Dave Morey  
Vice President  
Farley Project

Joseph M. Farley Nuclear Plant  
Verification Of Seismic Adequacy Of Mechanical And  
Electrical Equipment In Operating Reactors  
Unresolved Safety Issue (USI A-46), Generic Letter 87-02 RAI Response

## SNC RESPONSE TO GL 87-02 RAI

Figure 4.1-1: General Soil Profile at Main Plant Area  
(Ref. Rig. 2B5B-7 of FSAR)

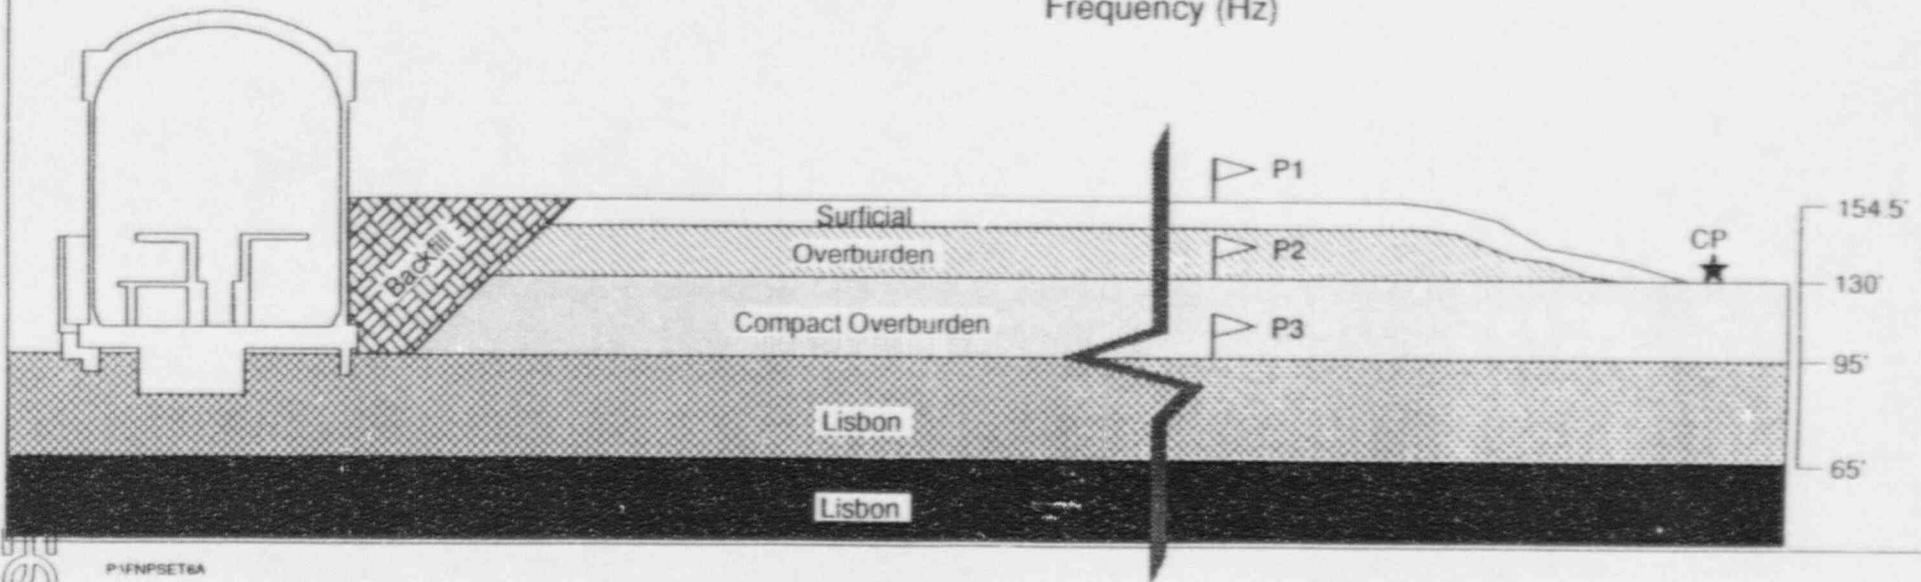
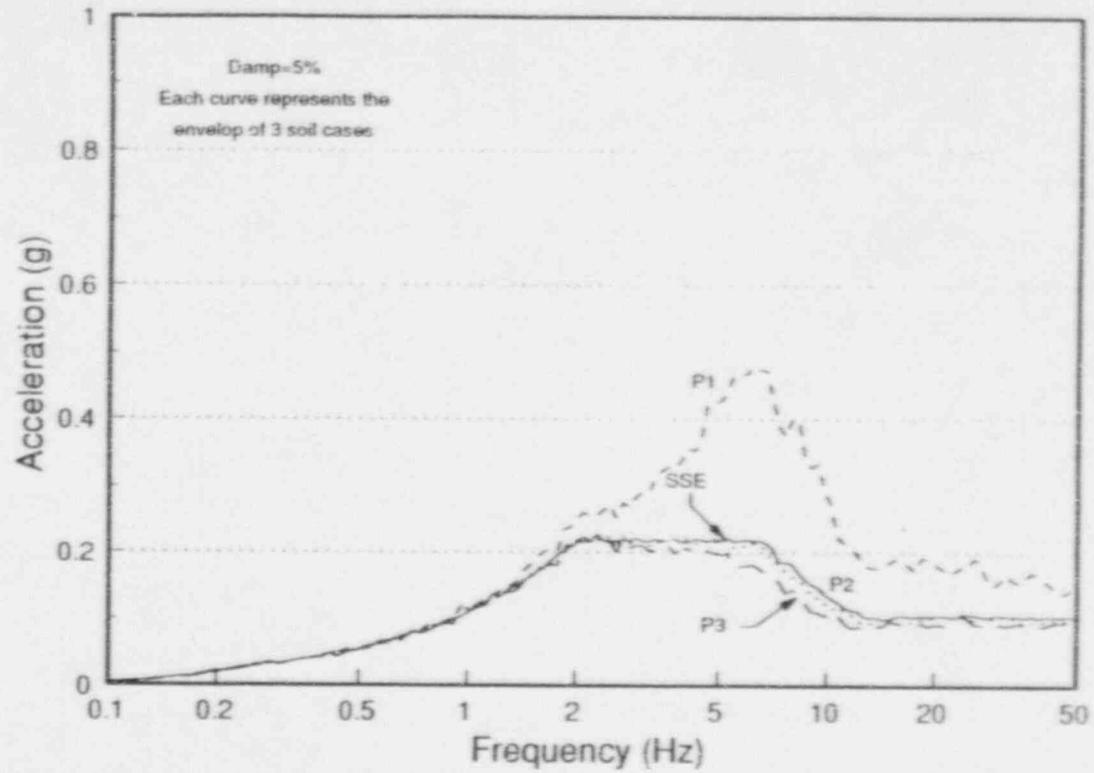
Discuss the basis for using the Compact Overburden layer that exists at 24.5 feet below grade at the main plant area as control point for the diesel building analysis. What is the shear wave velocity of the compact overburden layer? Also discuss the rationale for adopting the 85-feet below grade Lisbon formation as control point for the SWIS.

The DGB is located within the main plant area. The soil properties at the main plant area are given in Figure 2B5B-7 of the FSAR. Figure 4.1-1 of reference 6 (Attachment 1) summarizes the general soil profile and low strain dynamic properties. The top soil layers between grade (elevation 154.5') and elevation 130' comprise relatively soft material with initial shear wave velocity of 600-970 fps. Per the SRP (reference 7), the control point is defined either at grade or on a hypothetical outcrop of a competent layer at depth. The most

logical location for establishing the control point for this profile is, therefore, on the Compact Overburden layer at elevation 130' which has a shear wave velocity,  $V_s$ , of 2520 fps.

**Figure 4.1-4**

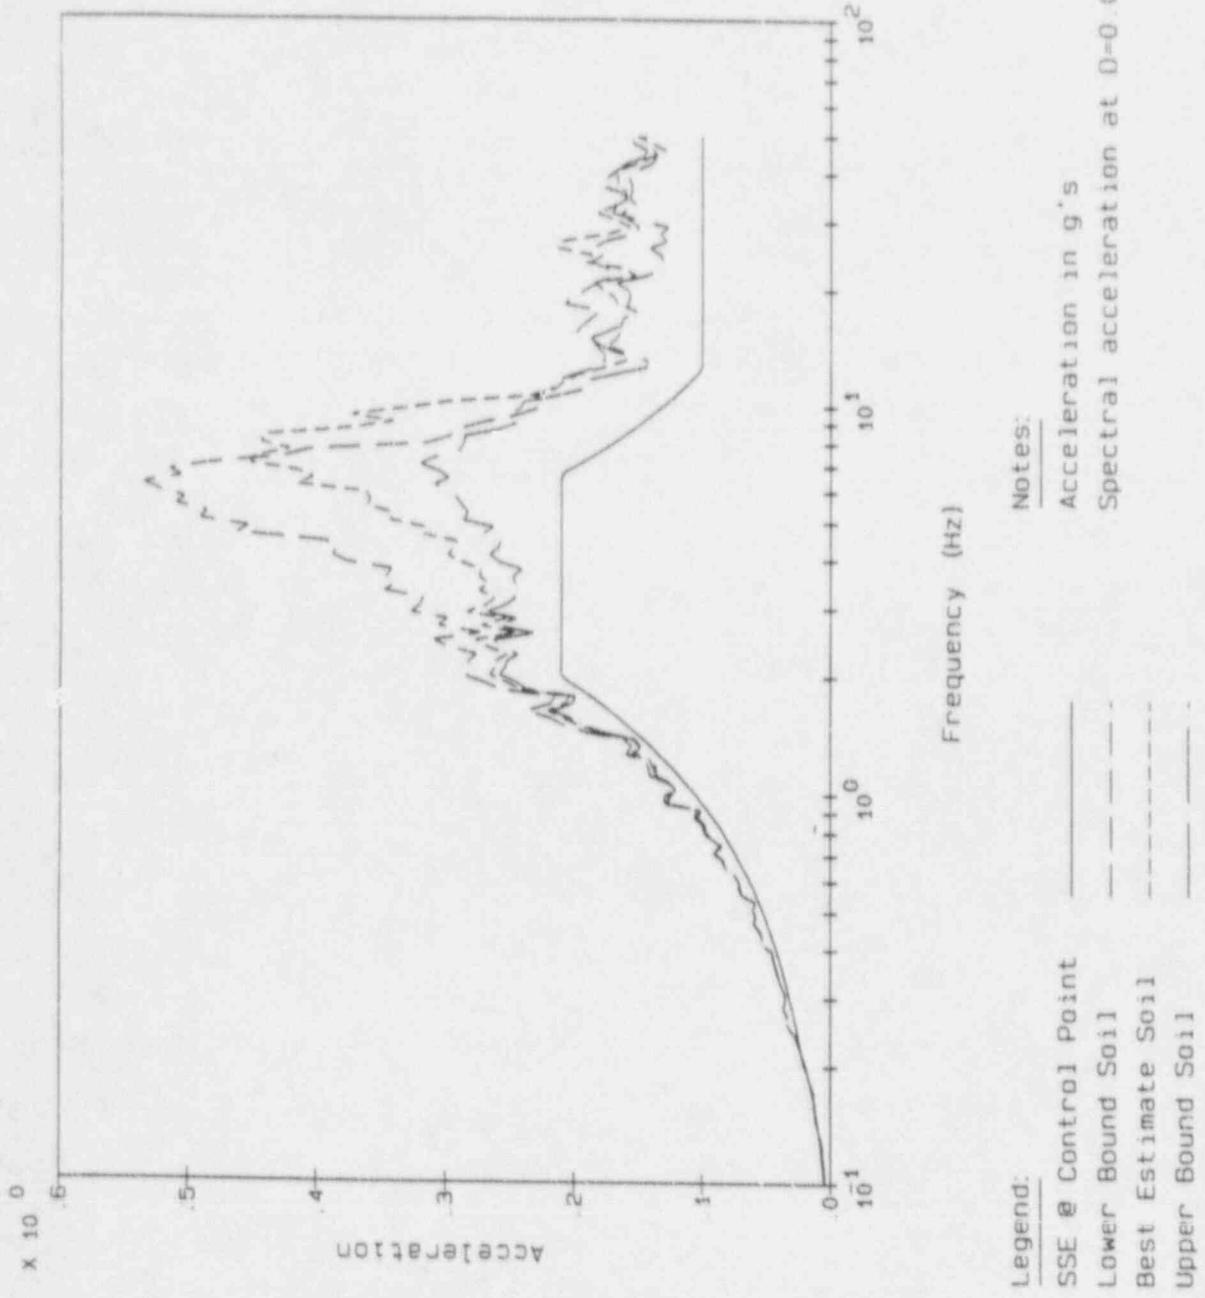
In your Final Safety Analysis Report (FSAR), you have committed to Appendix A to 10 CFR Part 100, which requires, in part, that, "Where the maximum vibratory acceleration of the Safe Shutdown Earthquake at the foundations of the nuclear power plant structures are determined to be less than one-tenth the acceleration of gravity (0.1 g)...., it shall be assumed that the maximum vibratory accelerations of the Safe Shutdown Earthquake at these foundations are at least 0.1 g." Based on the CLASSI/SHAKE analysis referred to in your response to question 6 of the August 29, 1996, staff request for additional information (RAI), did the computed maximum ground accelerations at the foundation levels of the diesel generator building (DGB) and service water intake structure (SWIS), as well as at grade elevation 155 feet, comply with the above quoted regulatory requirement? If the requirement in 10 CFR Part 100 was not met, justify your deviation from your FSAR commitment.

Since the DGB was treated as a surface founded structure supported on caissons, these surface motions (Figure 4.1-4), including the local site amplification effects, were used directly as input to the DGB's foundation level in the generation of new in-structure response spectra. Thus, the 10 CFR Part 100 Appendix A requirement of maximum ground motion assumed to be at least 0.10g at the foundation level in the freefield is satisfied for the DGB.

In regards to motion at plant grade, elevation 155', the foundation motion for the DGB in the freefield is the freefield motion at plant grade elevation 155' which has a ZPA approximately at 0.15g which is greater than the 10 CFR Part 100 Appendix A minimum of 0.1g.

Since the DGB was treated as a surface founded structure supported on caissons, the new ground surface motions including the local site amplification effects were used directly as input at the DGB's foundation level. Therefore, there was no reduction of motion at the foundation level, but an amplified SSE motion due to the conservative definition of the control point. This can be seen in Figure 4.1-4 of reference 6 (Attachment 1).

It should be noted that the new ground surface motion (Figure 4.1-4 of reference 6 provided in Attachment 1) developed for the surface founded tanks and used for seismic input for developing new DGB IRS is enveloped by the SQUG Boundary Spectrum. Therefore, using either the original SSE GRS defined at Plant Grade or the new ground surface motion based on defining the location of the SSE GRS some 24 feet below grade per the current SRP (reference 7) would not affect the results of using SQUG GIP Method A.1 seismic capacity to seismic demand screening for the equipment itself.

Figure 7.1-2: Diesel Generator Building: Estimating Frequency Shift Between FSAR Model and Current Analysis

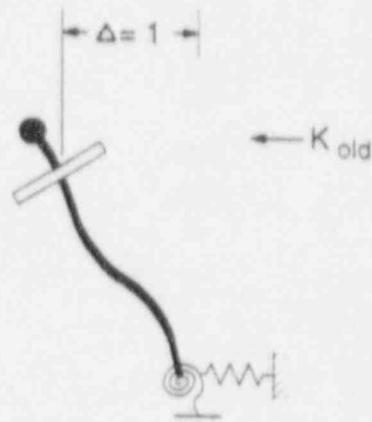
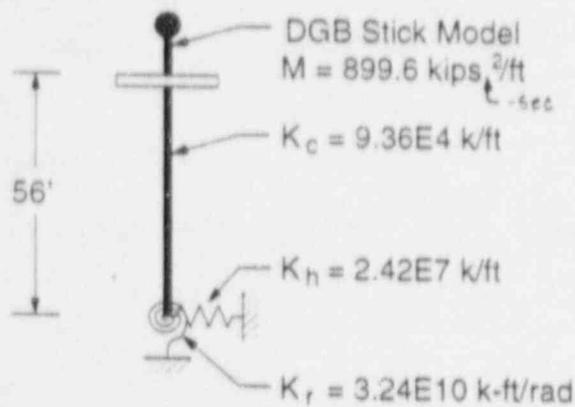
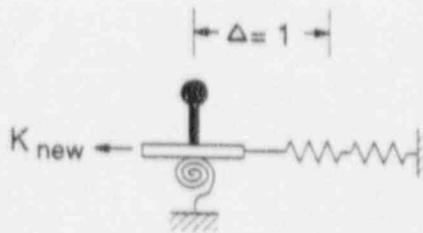
With respect to your response to question 6 of the August 29, 1996, staff's RAI, discuss the significance of changes in the amplitudes in the newly generated in-structure response spectra (IRS) for the DGB and SWIS as a result of using the CLASSI/SHAKE codes, which may have used a soil damping value different from the FSAR-specified limit of 7%. If a soil damping greater than the 7% value was used in the CLASSI/SHAKE-based analysis, provide justification for exceeding the FSAR value. Additionally, since you elected to employ the soil structure interactive approach, which is not referenced in your FSAR for performing the seismic analysis, discuss in detail how the following three provisions of Section 3.7.2 of the Standard Review Plan are incorporated in your analysis for generating the IRS: (1) limitation of the extent of reduction to foundation motion; (2) accounting of increased foundation rocking due to wave scattering; and (3) consideration of soil layering effects and frequency dependency of the foundation impedances. Also, discuss how the debonding of the top 20 feet of soil or half the embedment, whichever is less, was implemented in the embedded SWIS

The DGB is a stiff, single story shear wall structure with fundamental fixed base frequencies in excess of 27 Hz in the horizontal directions. Such a stiff building founded on soft soil is expected to result in a fundamental soil-structure mode where the structure responds as a rigid body.

The results of the new SSI analyses show that the fundamental soil-structure swaying mode is approximately 6.5 Hz for the best estimate soil case, as may be inferred from the spectral peak in Figure 7.1-1 of reference 6 (Attachment 1). This Figure also compares the current best estimate soil case with the original IRS. The most notable difference between the two analyses is a marked shift in the fundamental system frequency from about 1.6 Hz in the previous analysis to 6.9 Hz in the current analysis. This frequency shift is attributable to a major difference in the two analytical approaches -- the previous work modeled the entire 56' height of caissons as an equivalent freestanding column completely uncoupled from the surrounding soil. On top of this column was added the stick model of the DGB. Soil springs were then attached to the bottom of this column. Ignoring the lateral support provided by the soil surrounding the caissons resulted in an overly flexible system. The current analysis employed the impedance function approach and treated the caissons as a part of the soil medium. The frequency shift between the two approaches may be estimated by the simple calculation shown in Figure 7.1-2 of reference 6 (Attachment 1). In the FSAR analysis, the stiffness calculated based on the force required for unit displacement at the top of the caissons is  $9.24E4$  k/ft. This stiffness is derived mostly from the properties of the freestanding caisson. The total mass of the DGB including the basemat is  $899.6$  k-s<sup>2</sup>/ft. Therefore, the fundamental soil-structure frequency of the FSAR model is computed to be 1.61 Hz. In the current analysis, the impedance stiffness term for translation at the base of the DGB is about  $1.7E6$  k/ft. Therefore, the fundamental soil-structure frequency of the current model is 6.9 Hz. The actual frequency shift obtained in the analyses is shown in Figure 7.1-1 and corresponds well to the computed value. Another phenomenon that is treated differently between the original FSAR seismic analysis and the current methods is the

specification of seismic input. Applying the Farley SSE to the soil springs at the base of the caisson and propagating the motion up through the freestanding caissons over-simplified the actual physical phenomenon. The current study performed wave propagation analyses through the soil medium to establish the freefield surface motions for use in the SSI analyses. The spatial variation of seismic input along the height of the caissons may also be represented by wave scattering functions in the substructure method. However, the DGB caissons are flexible relative to the surrounding soil mass and wave scattering effects are minimal for horizontal excitation. Therefore, a surface foundation was assumed in the SSI analysis for the DGB.

The peak spectral acceleration (SA) of the new DGB IRS is slightly lower than the peak SA of the original DGB IRS. This is due to the fact that the modern SSI analysis approach used to calculate the new IRS, which satisfies the current SRP (reference 7), properly models the behavior of the soil layers below the DGB and implicitly accounts for soil radiation of energy effects which is typically a major contributor to any reduction in the SA amplitude. Also strain compatible soil material damping or hysteretic soil damping was considered following SRP requirements, but this effect is less a contributor to any reduction in the SA amplitude.
